RESPONSE TO SUBMISSIONS

SCEGGS Darlington -
Modification 3
SSD-8993-Mod-3

Figure 1 Updated Landscape Masterplan

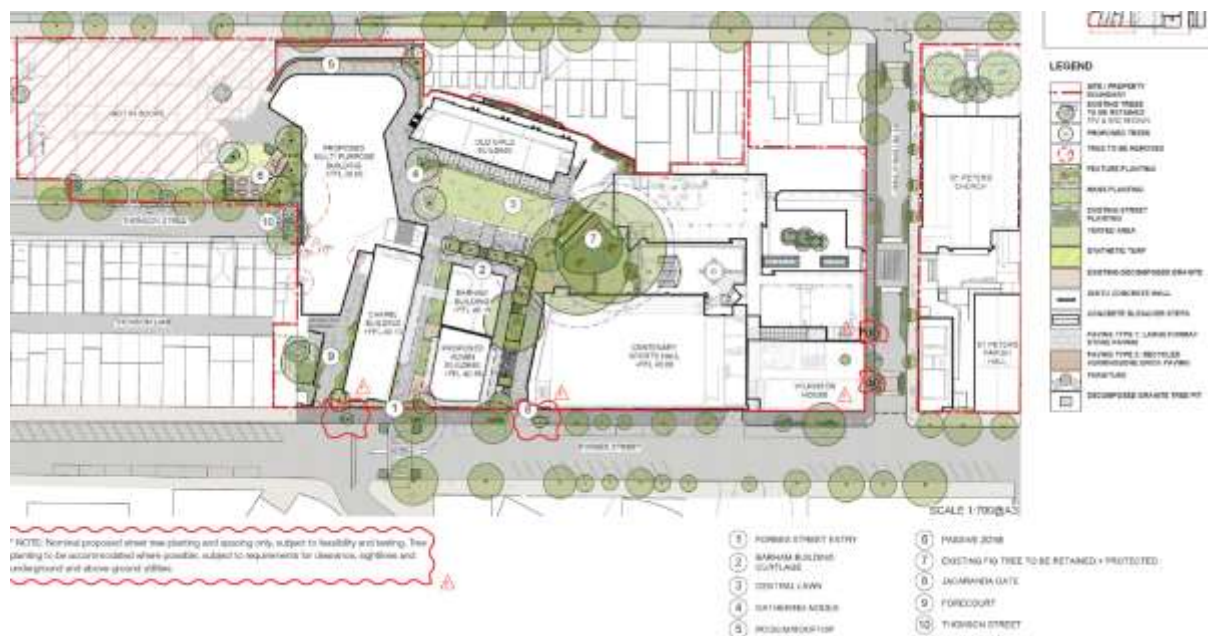
As part of the exhibition for Wilkinson House Detailed SSDA, DPE and Council requested to explore alternative landscaping opportunities within or around Wilkinson House. In response to DPE and Council, the project team proposed additional street trees along Forbes Street and St Peter Street frontages, to enhance greenery in the streetscape.

The detail of the additional trees will be documented in detailed Landscape Plan accompanying the Wilkinson House detailed SSDA RtS. For consistency, the locations of the trees are reflected on the Landscape Masterplan as illustrated below.

The tree species recommended are consistent with City of Sydney Street Tree Master Plan, and is also consistent with the existing street trees along these frontages.

Figure 2 Roof Extension

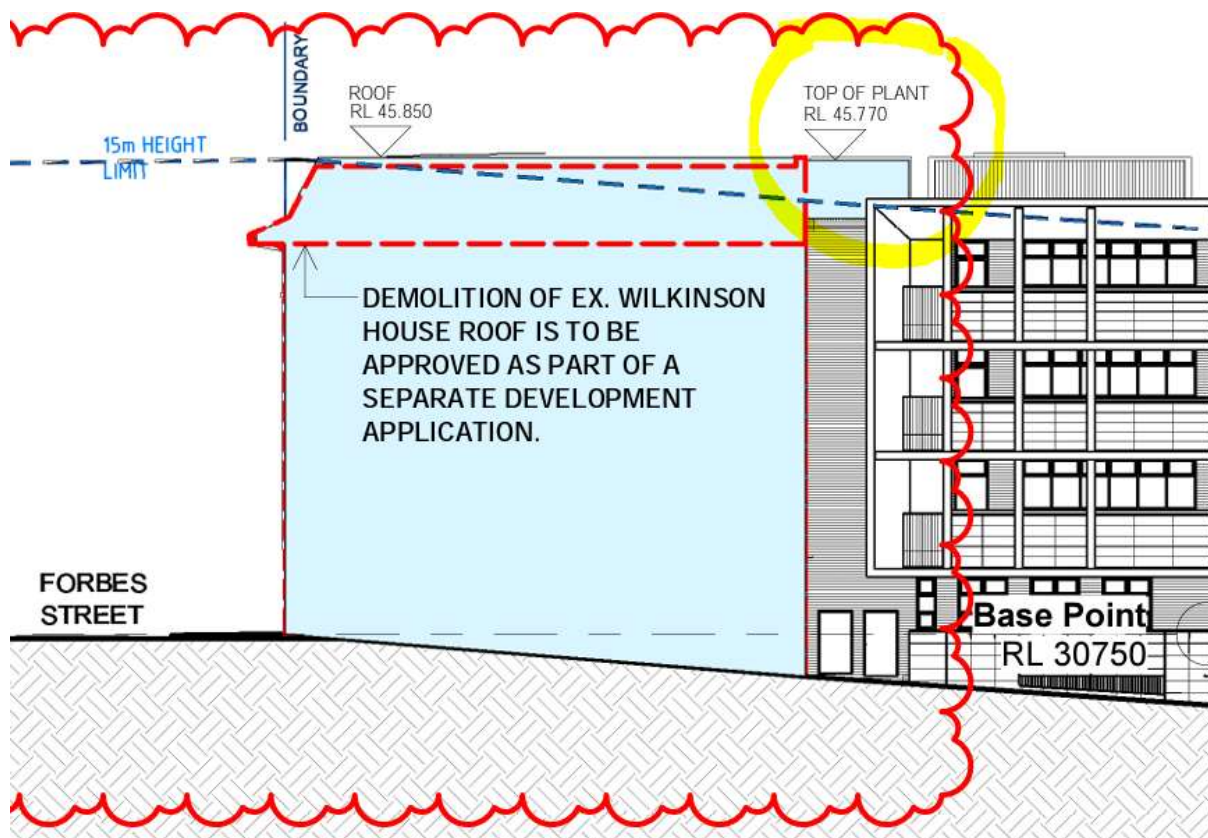
4.2. VISUAL IMPACT OF THE PLANT ENCLOSURE EXTENSION ON THE ROOF OF JOAN FREEMAN BUILDING

The proposal comprised a minor western extension of the building envelope for Wilkinson House to extend above the roof of Joan Freeman building to allow for a plant enclosure for condenser units (as proposed under the concurrent SSDA for Wilkinson House). It is important to clarify that the extension is located on top of the fire staircase portion of the Joan Freeman building (not the main portion of the building), which is further setback from the main façade of the Joan Freeman building.

The building envelope extension has a maximum RL of 45.77, which matches the maximum height of the existing Joan Freeman building (refer to Figure 2). The height of the extension is slightly below the proposed building envelope height of Wilkinson House.

The proposed envelope extension will not be readily visible from the street, because:

- A height datum has already been established by the existing carpark exhaust riser of the Joan Freeman Building, so the envelope extension will blend in with existing service structure.
- The location of the envelop extension is setback from the street and the envelope of Wilkinson House and Joan Freeman building. Therefore is not easily perceived from the street.
- The detailed design of the plant enclosure within the envelope extension is shown in the Detailed SSDA for Wilkinson House. The plant enclosure will be screened, using dark brick treatment to ensure its recessive character.
